# MR #2023007 – TUCKERMAN LANE SIDEWALK/BIKEWAY PROJECT – SEGMENT 1 MANDATORY REFERRAL

## Description

NO. MR #2023007

Figure 3 Montgomery County Bicycle Master Plan Bicycle Network Map

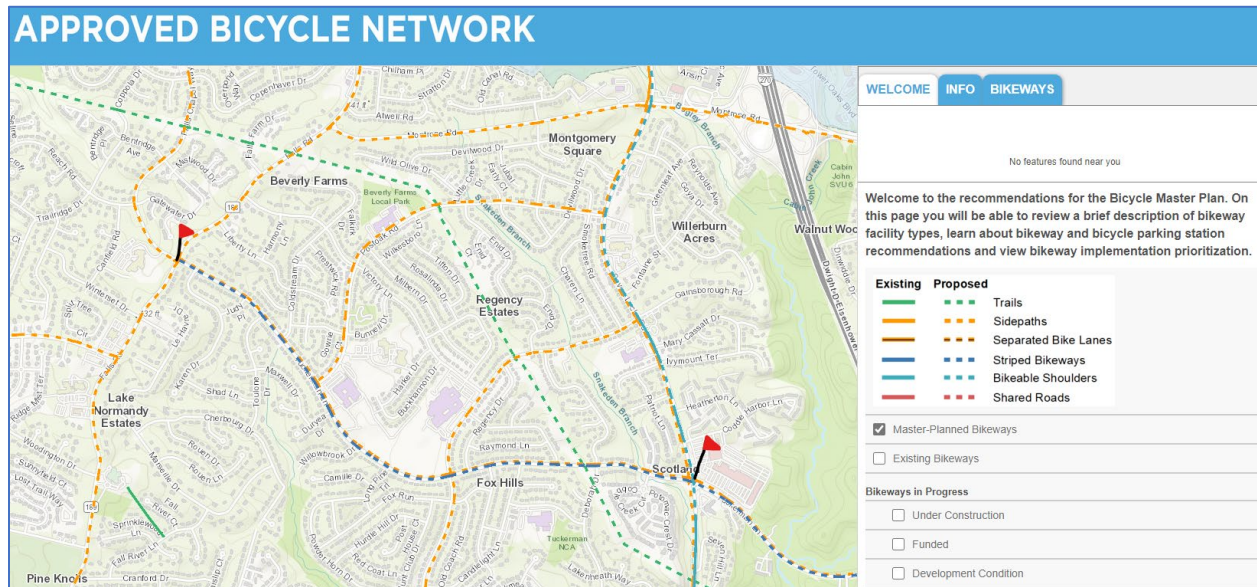
A Montgomery Parks project titled the Powerline Trail will create a paved and natural surface trail along the Pepco powerline corridor. A section of this project will cross Tuckerman Lane within the project area and is anticipated to begin construction in late 2024. The crossing will be located between Deborah Road and Georgetown Drive. This can be seen as the dashed green line cutting across Tuckerman Lane in Figure 3.

**Recommendation: Coordinate with the Montgomery Parks to install a protected crossing as part of the Powerline Trail project.**
